**U.S. NUCLEAR  
REGULATORY  
COMMISSION REQUEST  
FOR AMMENDMENT**

APPLICATION FOR AMENDMENT TO  
U.S.N.R.C. LICENSE #42-23889-01E  
FOR THE APPROVED SEALED SOURCE & DEVICE  
EVALUATION  
& REGISTRATION CERTIFICATE #NR-1180-D-101-E

The model numbers designated for these new products are revisions to the already existing and approved TG131/TG231 Series Gun Sights as listed in Registration Certificate # NR-1180-D-101-E amended on 3-11-13.

TG131/TG231 Series – Revision 3

**TG 131 Series-A1**

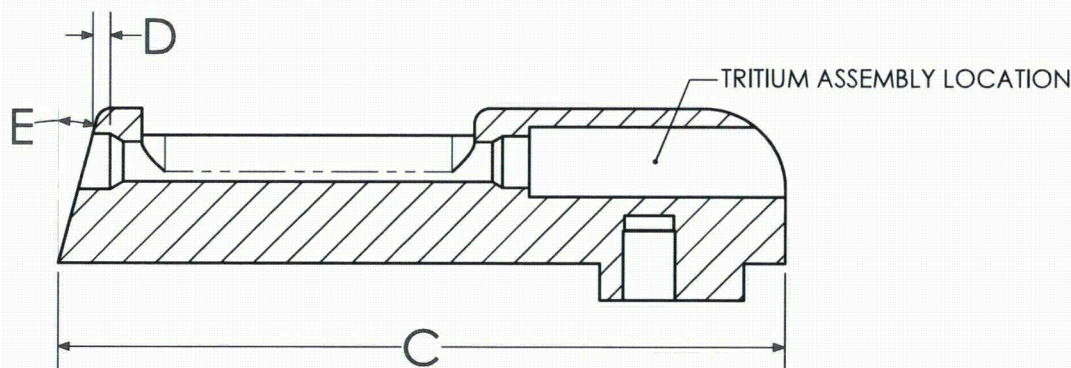
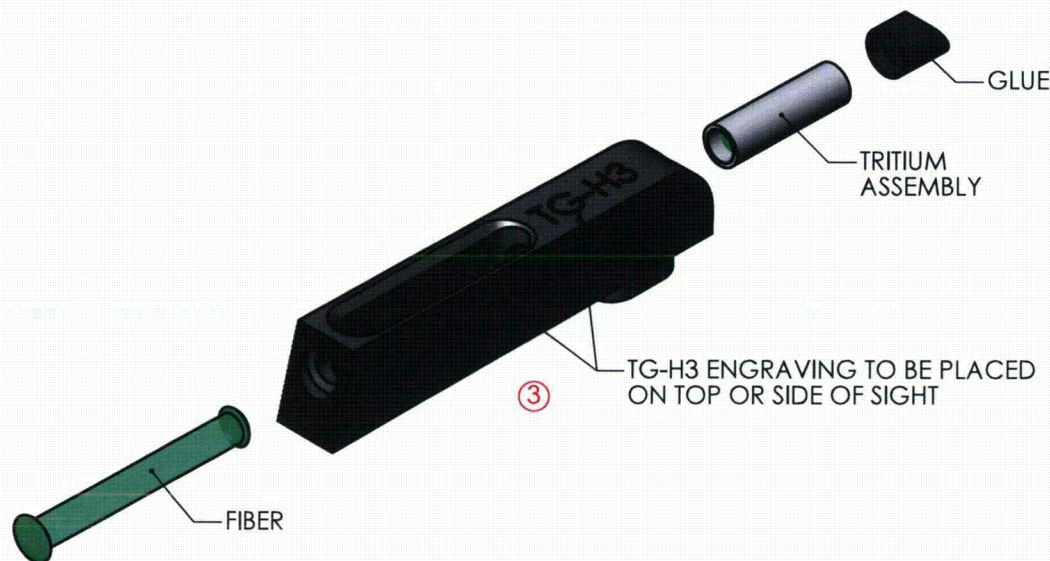
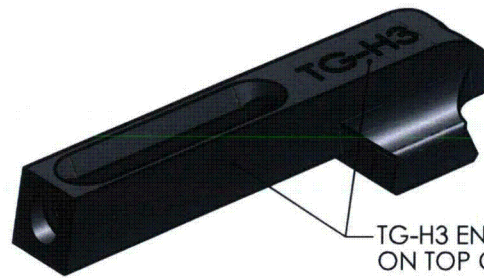
3 ADDED MODEL TG131WT, UPDATED BORDER, COLLECTED NOTES, ADDED EXPLODED VIEW

**TG 131 Series-A2**

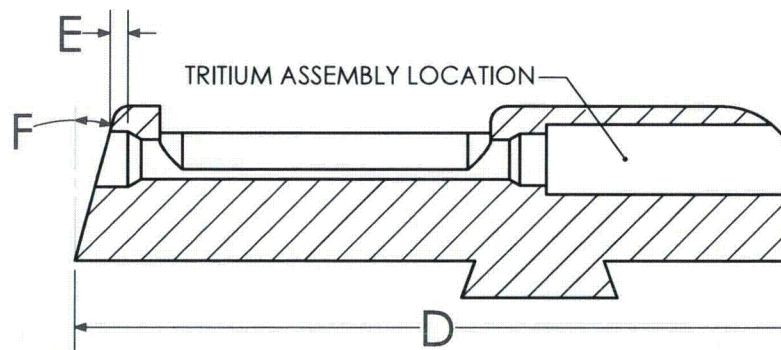
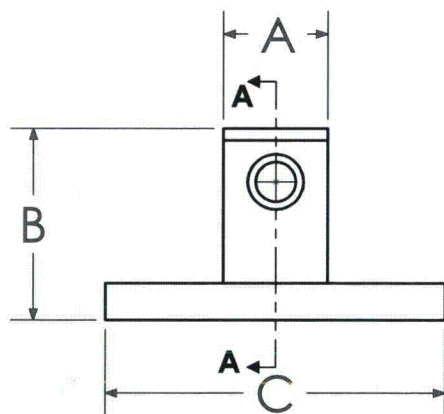
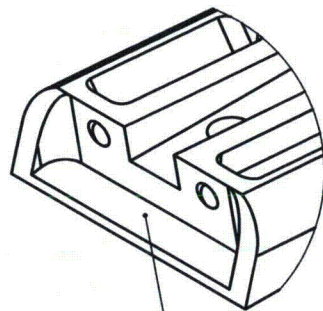
REV	DESCRIPTION	DATE	APPROVED
3	ADDED SEVERAL MODELS (SEE TABLE), UPDATED BORDER, COLLECTED NOTES	10-22-2013	G.WEBB
2	ADDED MODEL 'TG131MPT', UPDATED BORDER, ADDED NEW EXPLODED VIEW	3-5-2010	J.ESTRIDGE
1	RELEASE TO PRODUCTION	5-20-2003	K.NORMAN

**TG 131 Series-B1**

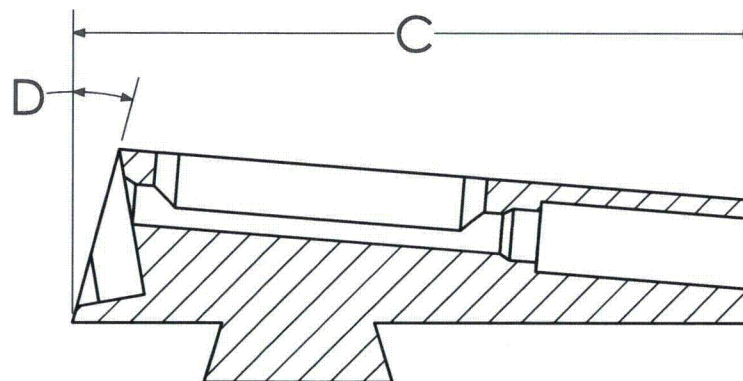
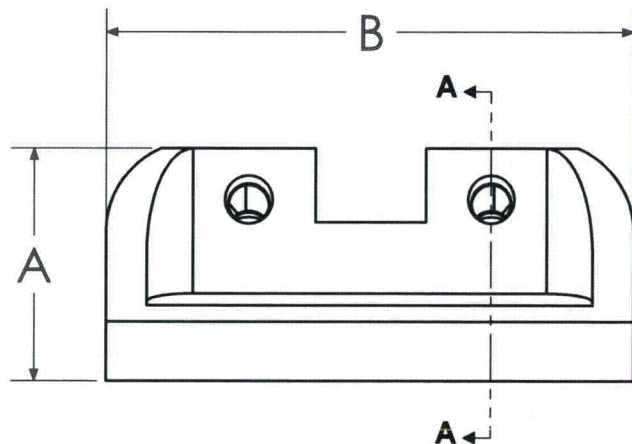
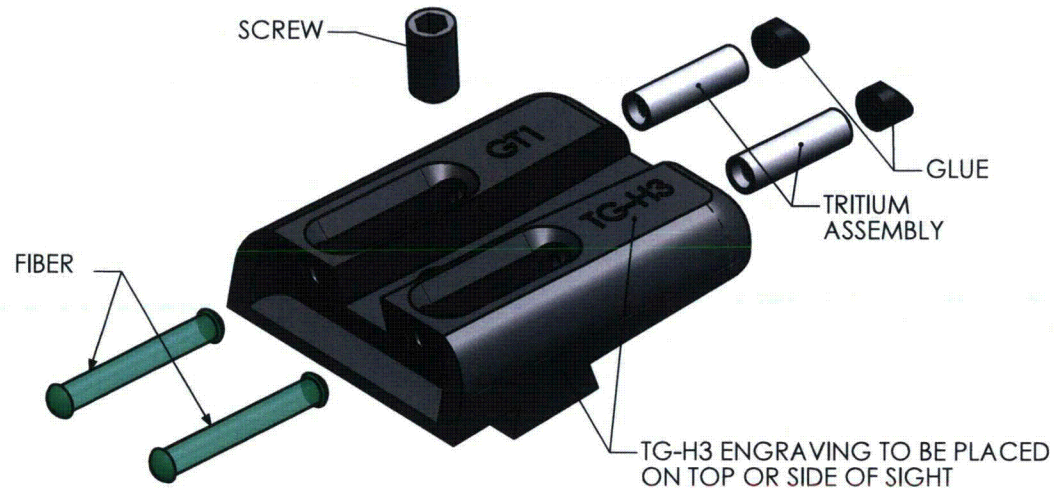
REV	DESCRIPTION	DATE	APPROVED
3	ADDED NEW MODELS (SEE CHART), UPDATED BORDER, COLLECTED NOTES	10-24-2013	G.WEBB
2	ADDED MODEL 'TG131MPT', UPDATED BORDER, ADDED NEW EXPLODED VIEW	3-5-2010	J.ESTRIDGE
1	RELEASE TO PRODUCTION	5-20-2003	K.NORMAN

DESCRIPTION  
**TG231 Series-A1**

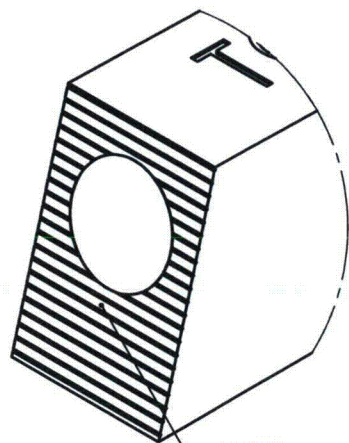
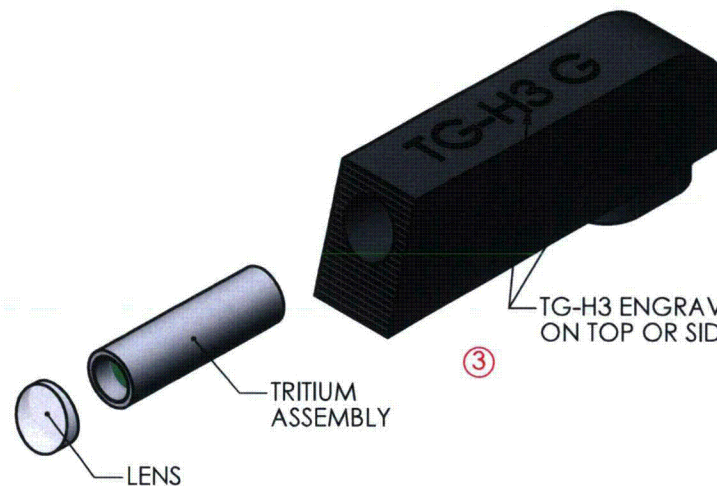
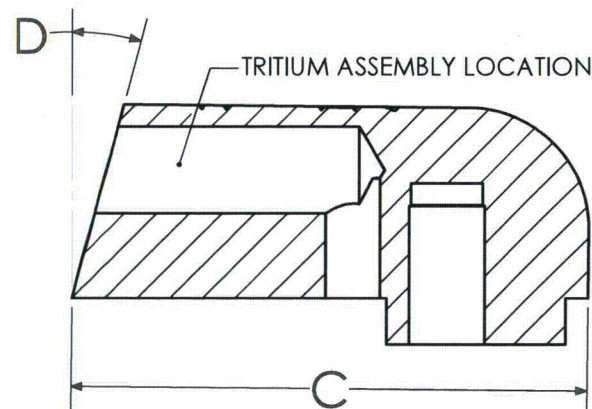
REV	DESCRIPTION	DATE	APPROVED
3	ADDED MODEL "TG131W", UPDATED BORDER, ADDED EXPLODED VIEW, COLLECTED NOTES	10-28-2013	G.WEBB
2	ADDED ENGRAVING NOTE/ DELETED PROPRIETARY INFORMATION NOTES	9-8-2003	K.NORMAN
1	RELEASE TO PRODUCTION	5-20-2013	K.NORMAN

DESCRIPTION  
**TG231 Series-A2**

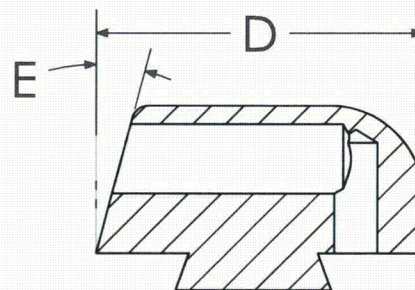
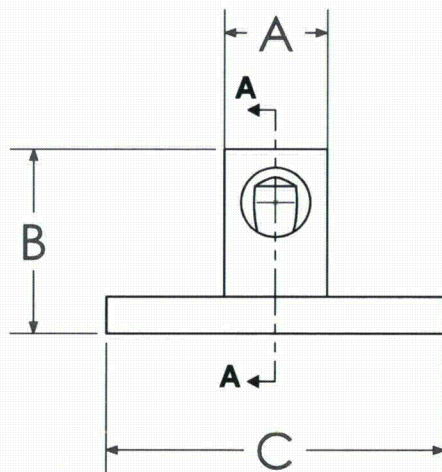
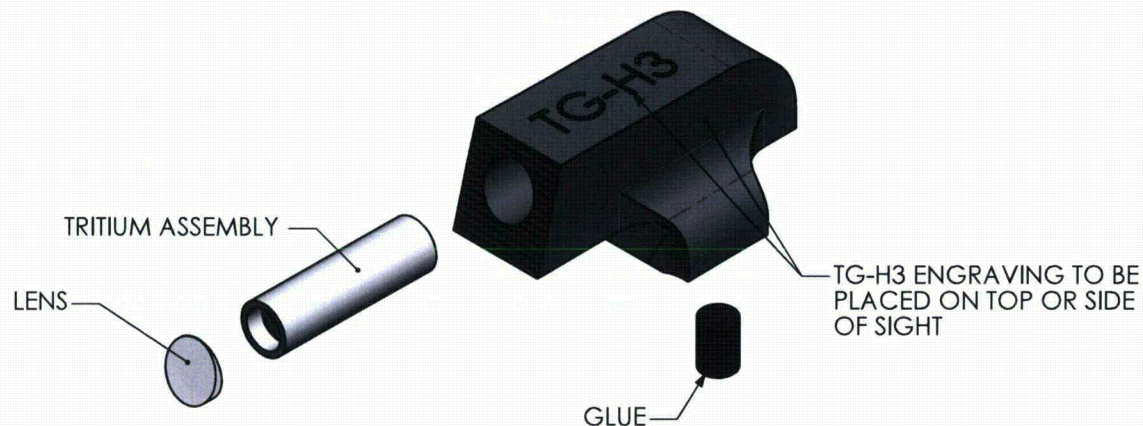
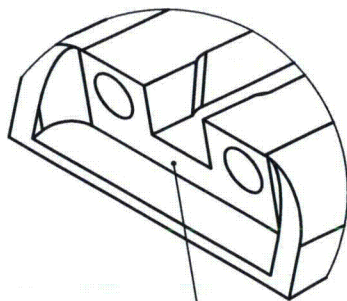
REV	DESCRIPTION	DATE	APPROVED
3	ADDED SEVERAL MODELS (SEE TABLE), UPDATED BORDER, COLLECTED NOTES	10-20-2013	G.WEBB
2	ADDED MODEL "TG231MP"; UPDATED BORDER; ADDED EXPLODED VIEW	3-5-2010	J.ESTRIDGE
1	RELEASE TO PRODUCTION	5-20-2003	K.NORMAN

DESCRIPTION  
**TG231 Series-B1**

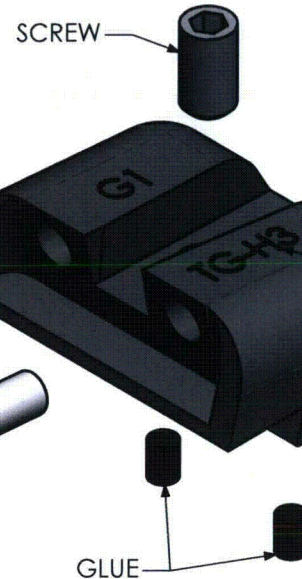
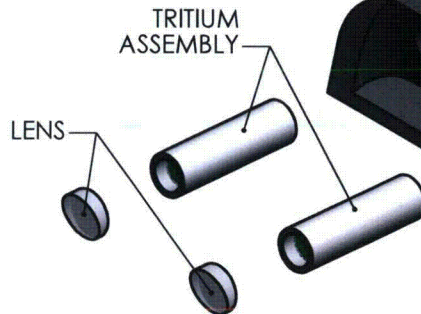
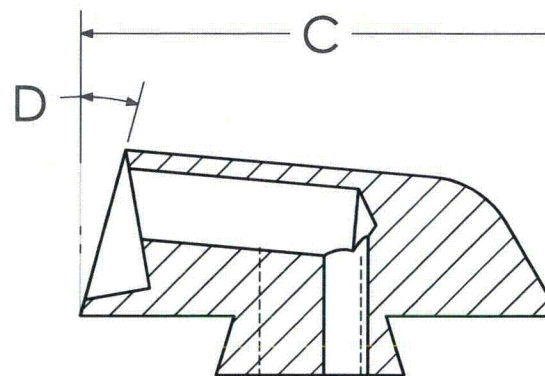
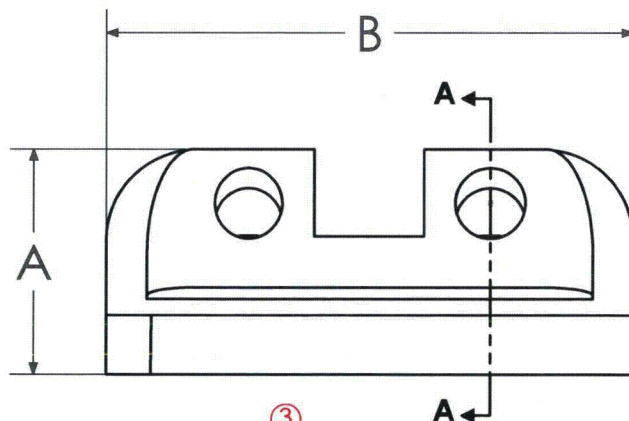
REV	DESCRIPTION	DATE	APPROVED
3	ADDED SEVERAL MODELS (SEE TABLE), UPDATED BORDER, COLLECTED NOTES	10-24-2013	G.WEBB
2	ADDED MODEL "TG231MP", UPDATED BORDER; ADDED EXPLODED VIEW	3-5-2010	J.ESTRIDGE
1	RELEASE TO PRODUCTION	5-20-2003	K.NORMAN
